Addendum # 02.2

McKay Dee Hospital Cath Lab 4 Replacement
4401 Harrison Blvd.
Ogden, UT 84403

Mechanical Addendum #2

MD103

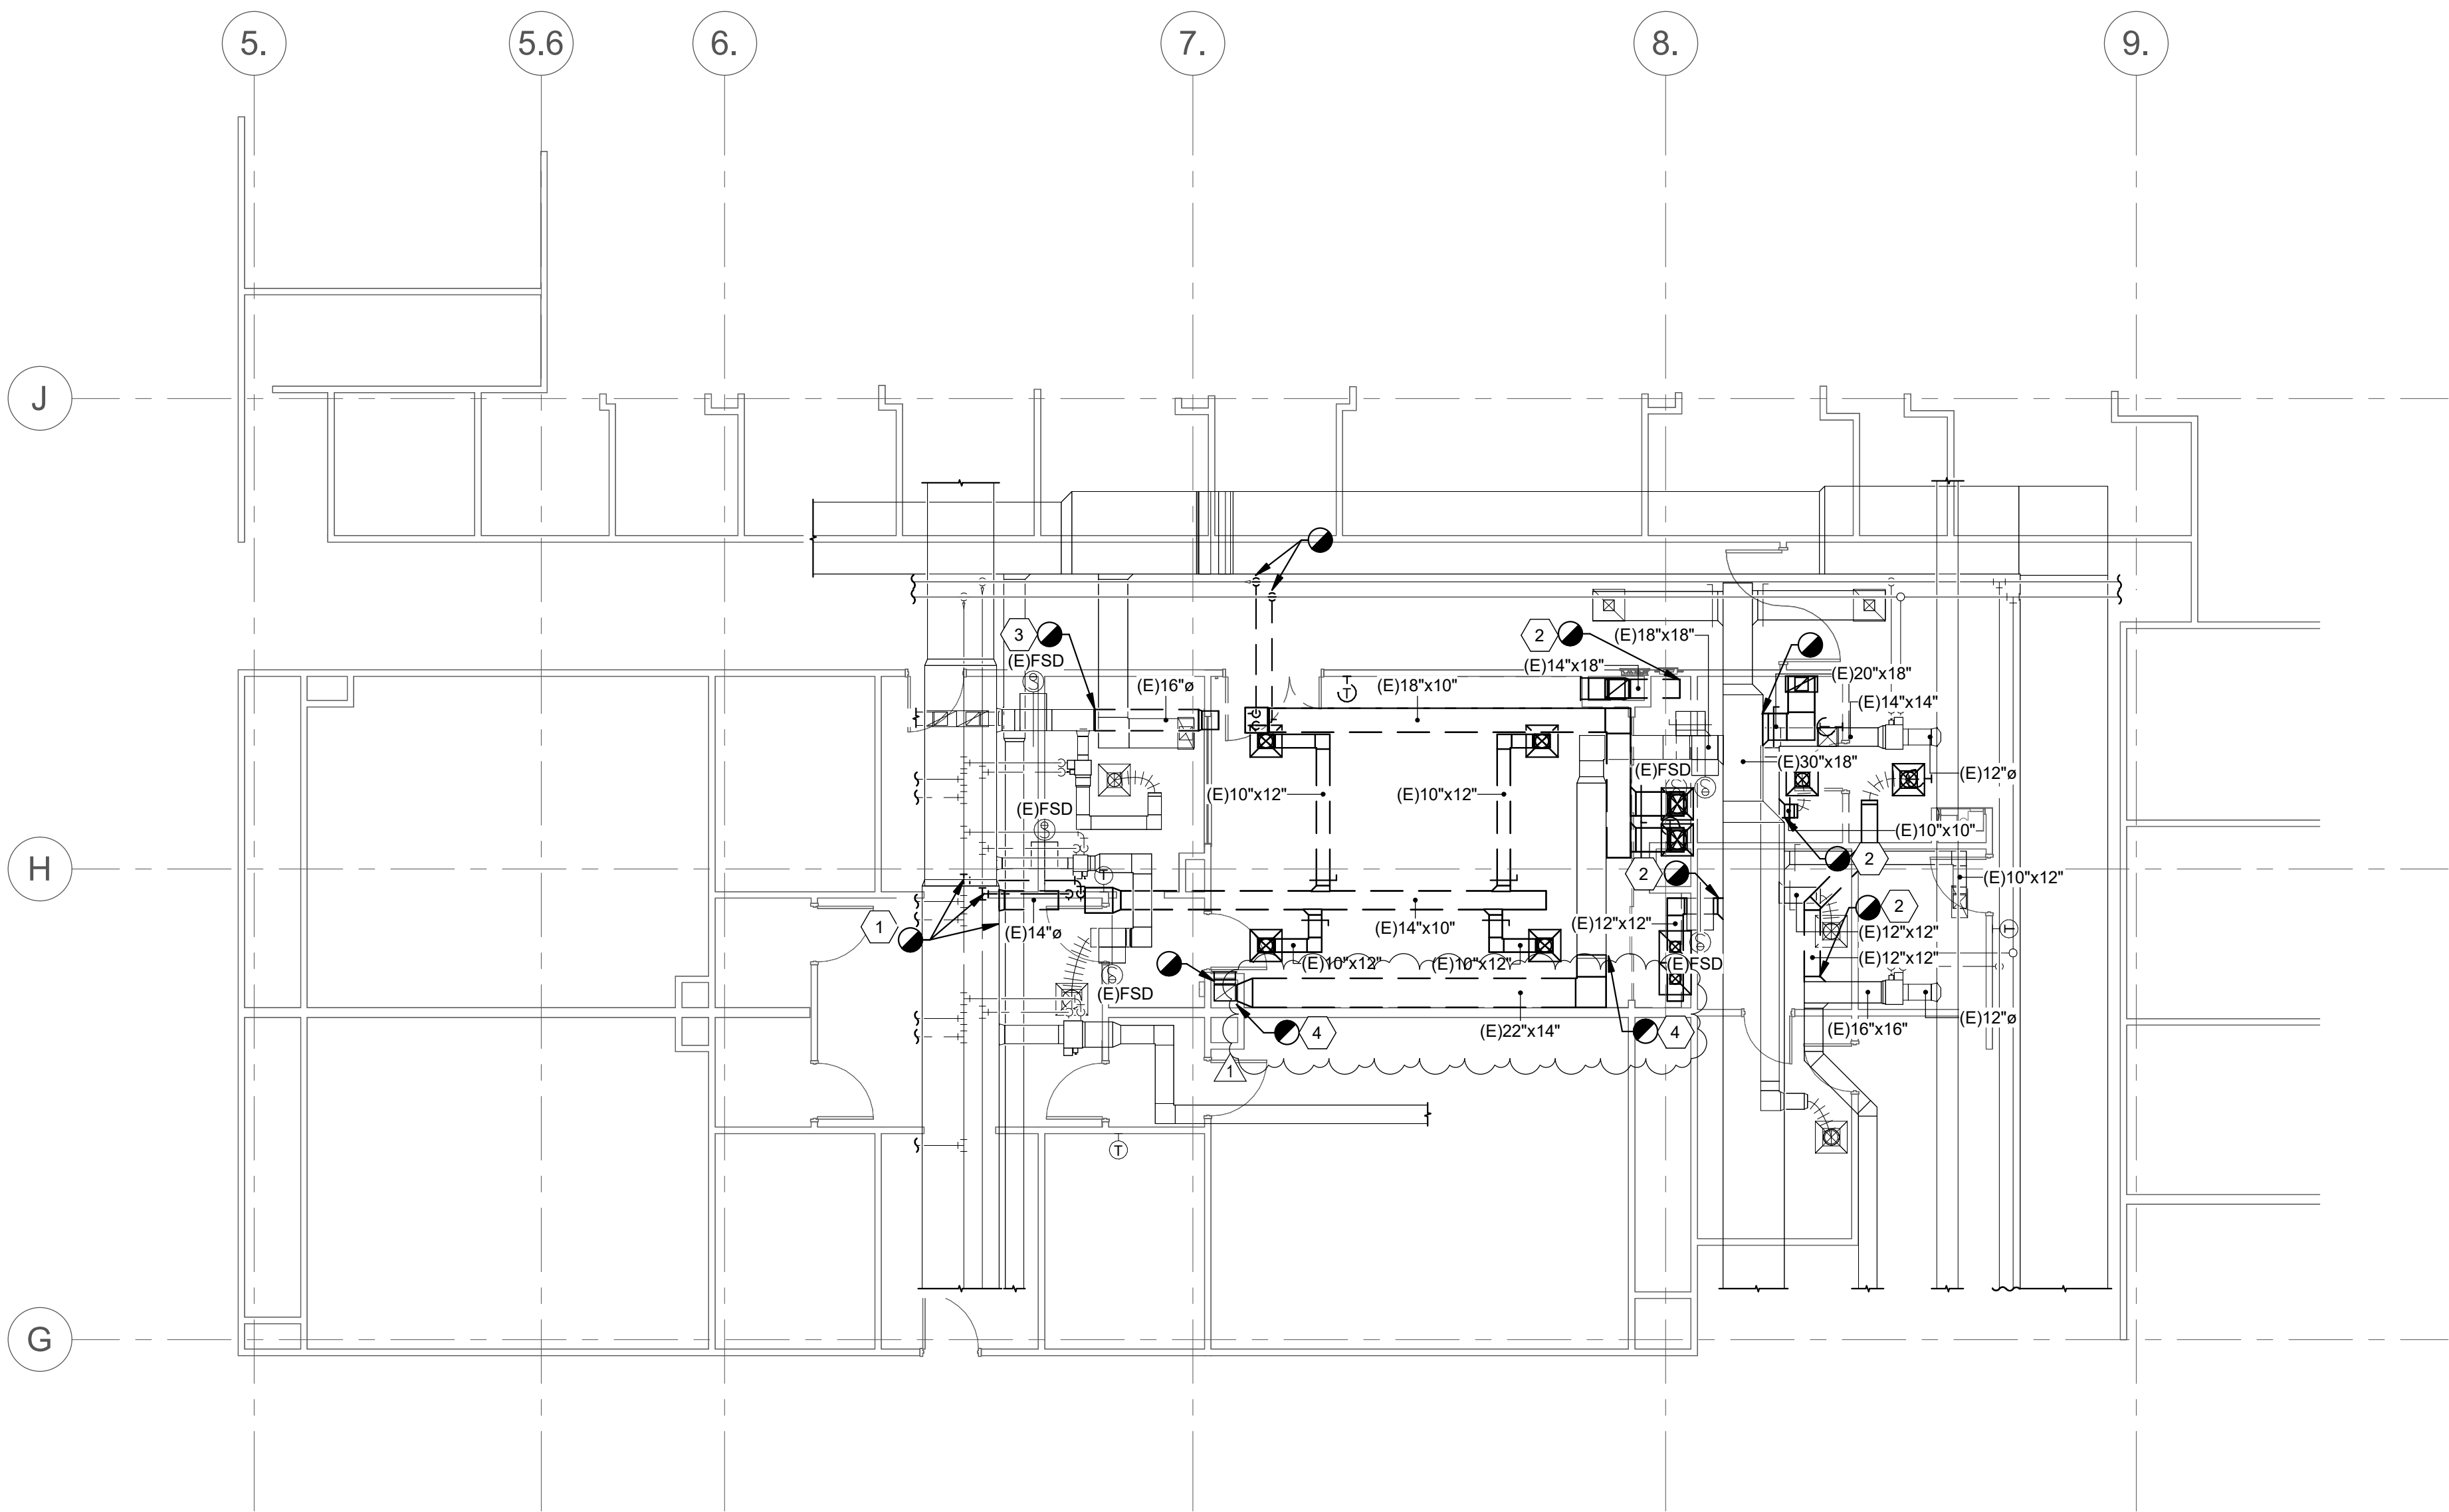
- a) See response to item #2.
- 4) Another item I'm wonder is about the existing 22"x14" duct. Is it going to conflict with all the new booms and the angle supports?

1. MD103 - LEVEL 3 MECHANICAL DEMOLITION PLAN
 - a. Remove existing ductwork for new structural supports
2. M103 - LEVEL 3 MECHANICAL PLAN
 - a. Install ductwork to work around structural supports
 - b. Provide pressure monitor per code comments
 - c. Provide additional laminar flow diffuser per code comments
3. M601- MECHANICAL SCHEDULES
 - a. Scheduling for laminar flow diffuser
4. PD103 - LEVEL 3 PLUMBING DEMOLITION PLAN
 - a. Demolish existing medical gas alarm panel
5. P104 - LEVEL 3 PLUMBING PLAN - MED GAS
 - a. Replace existing medical gas alarm panel per information provided by contractor.

- a) Please see updated mechanical and structural drawings
 - b) The existing duct work will need to be moved so that we can get approximately 18" away from the east wall. This will allow me to provide a equipment mount that can wrap around the duct work and still support the equipment below the duct work, see sketch detail SK1.1 enclosed for the necessary information.

PD103

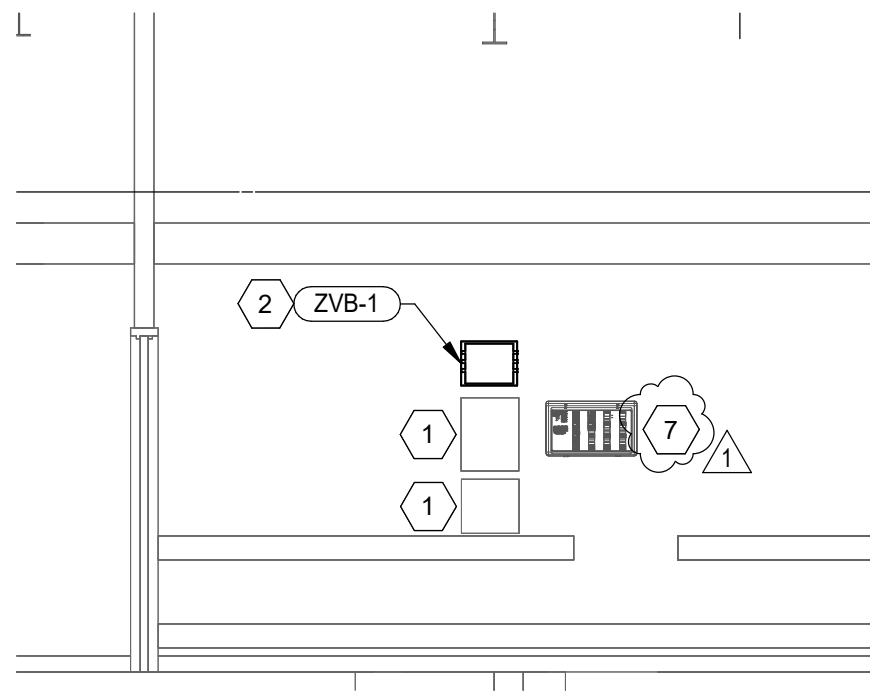
- 5) The plans call to add an additional gas to the alarm panel serving the cath lab. It's a Beacon Medas Total Alert 2 alarm, which is a discontinued alarm panel. The only option is to retro fit an entire new alarm panel in its place. It may be too late to ask question of the engineer, but if you can, this would be a good one to address or it will be a change order that will affect every zone monitored by that alarm.

REMOVE EXISTING MEDICAL GAS ALARM PANEL.

1 LEVEL 3 PLUMBING PLAN - MED GAS

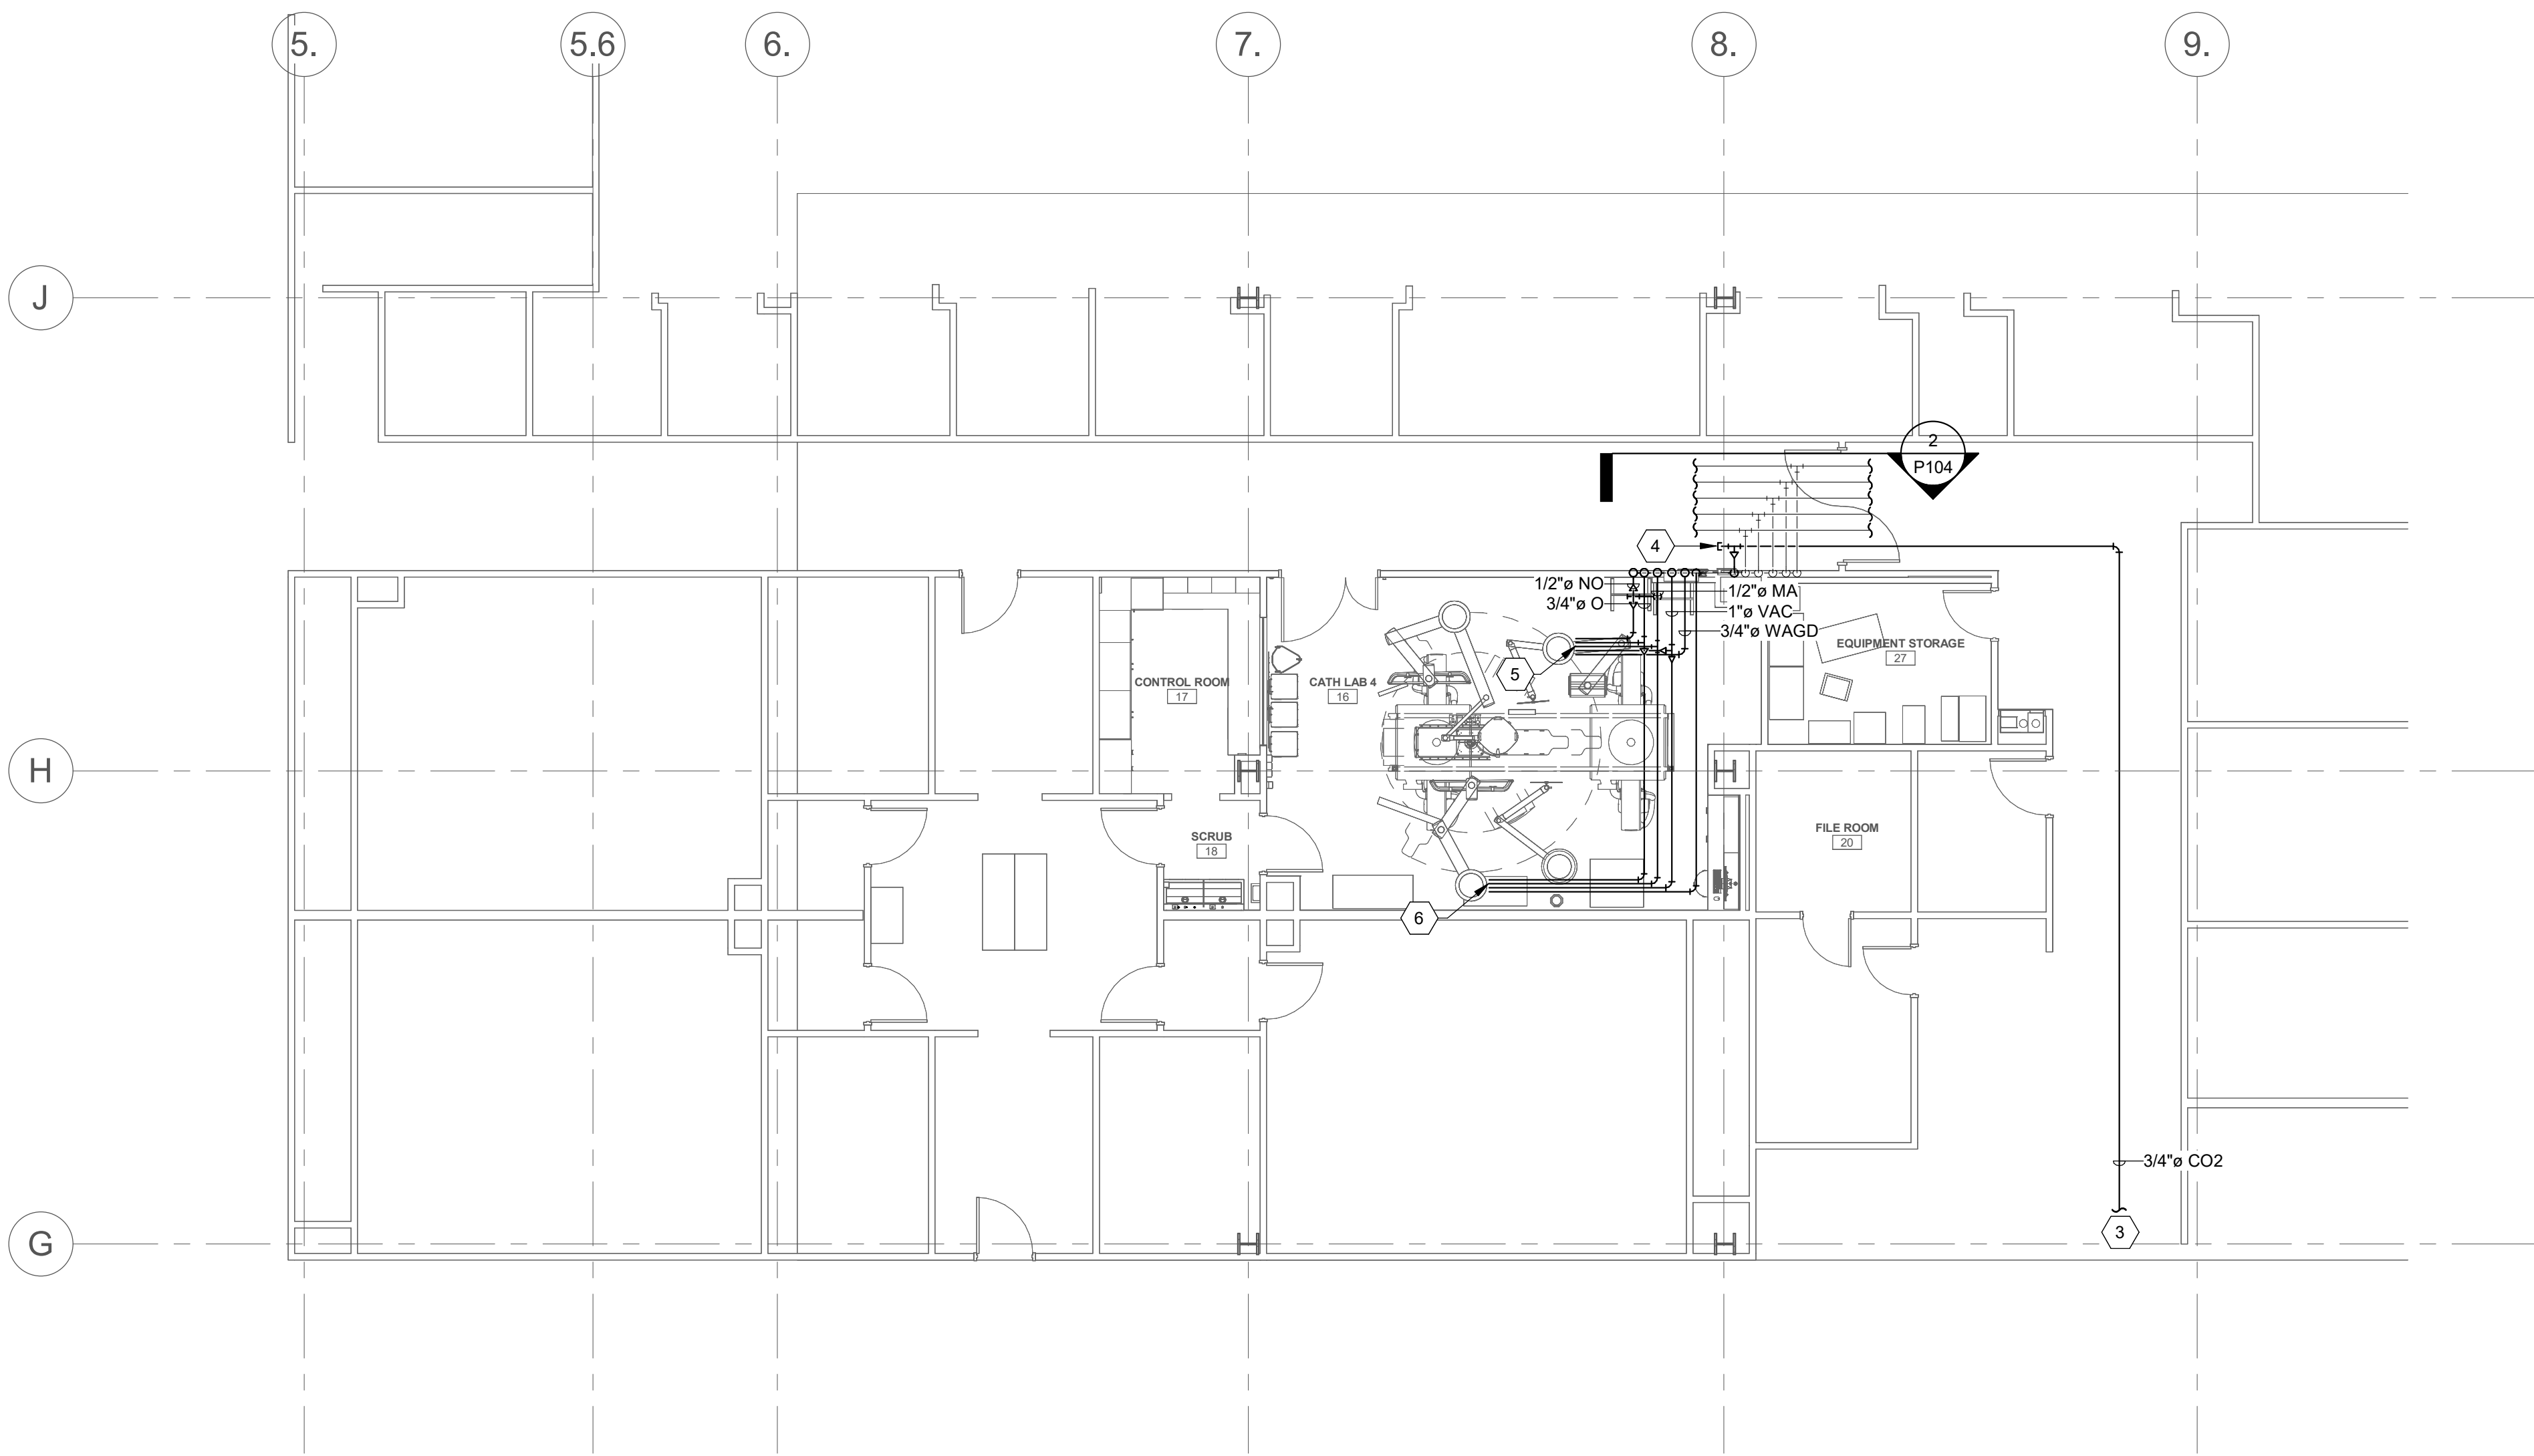
- a) Please see updated mechanical drawings and schedule.
- 6) I have spoken with 2 different certifiers and have confirmed Beacon Total Alert 2 alarm panels and retrofit parts are no longer available so upgrading the existing alarm panel IS NOT an option, it will have to be completely changed.

- a) Please see updated mechanical drawings and schedule.

- EXISTING ZONE VALVE BOX TO REMAIN.
- INSTALL NEW ZONE VALVE BOX ABOVE EXISTING ZONE VALVE BOXES.
- ROUTE CO2 LINE DOWN CORRIDOR, THROUGH REHAB GYM AND RECORDS ROOM TO EXISTING CHASE. ANTICIPATED DISTANCE FROM THIS POINT TO CHASE: 150'. CONTRACTOR TO COORDINATE SHUTDOWN AND RECERTIFICATION WITH FACILITIES 48 HOURS IN ADVANCE.
- STUB CO2 LINE FOR FUTURE CONNECTION.
- ROUTE MEDICAL GAS LINES TO NEW ANESTHESIA BOOM, SKYTRON TO MAKE CONNECTION TO BOOM. GAS SIZES ARE AS FOLLOWS.
NO: 1/2"
O2: 1/2"
MA: 1/2"
VAC: 3/4"
WAGE: 3/4"
- ROUTE MEDICAL GAS LINES TO NEW PERFUSION BOOM, SKYTRON TO MAKE CONNECTION TO BOOM. GAS SIZES ARE AS FOLLOWS.
O2: 1/2"
MA: 1/2"
VAC: 3/4"
CO2: 1/2"
- PROVIDE NEW MEDICAL GAS ALARM PANEL TO SERVE CATH LAB. BASIS OF DESIGN BEACON MEGAS A10-0XAVW
